Technical Service Bulletin

Tech Service Bulletin #: TSB16-01

Date: 11/30/2016

Inspect for loose jam nut on EBW plunger

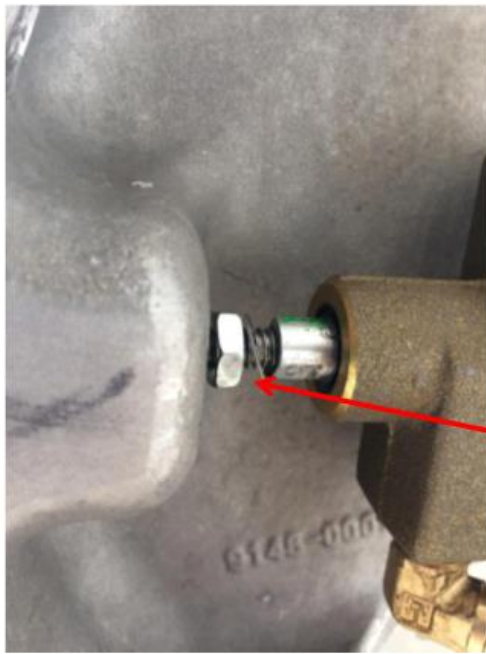
Heil Trailer International has reason to believe a loose fastener on a brake interlock valve located at the discharge outlet load bar area could be possible on some petroleum trailers shipped from September 1, 2016 till November 18, 2016. Our records indicate that you have received a new petroleum unit since the aforementioned date; therefore, we are asking you to please inspect your new petroleum trailers per the instructions given below.

If you find a loose adjustment screw or set nut on the brake interlock valve at the load bar area, please call 1-800-400-6913 extension 4 for further instructions. If the parts are tight, no actions are required with the exception of responding as mentioned below.

Install nut and star washer in the EBW

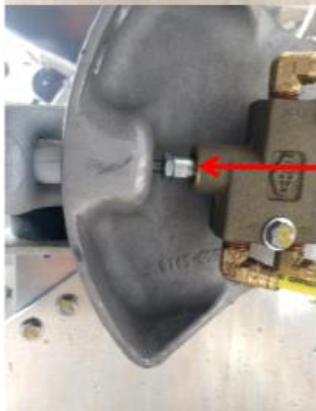
Ensure threads are not damaged and has a star washer between the nut and the EBW plunger.

Example of plunger out of adjustment.

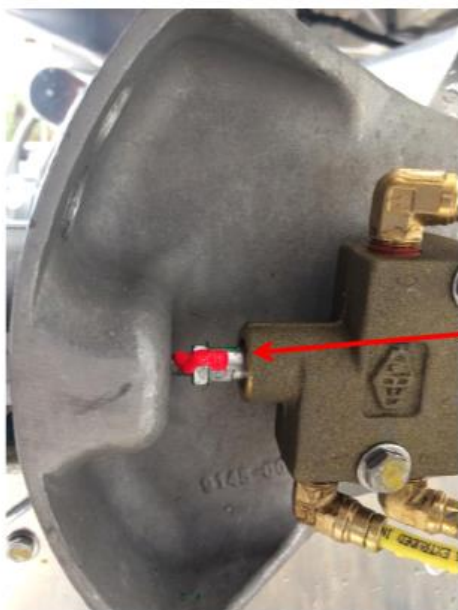
If adjustment is needed:

- Raise bar interlock
- Back out the screw a few turns from plunger
- Check to make sure plunger is fully depressed by lowering the bar interlock (may require multiple adjustments)
- Once plunger is fully depressed, tighten nut and star washer

Recommend adding a witness mark to visually show if the nut and plunger becomes out of adjustment.
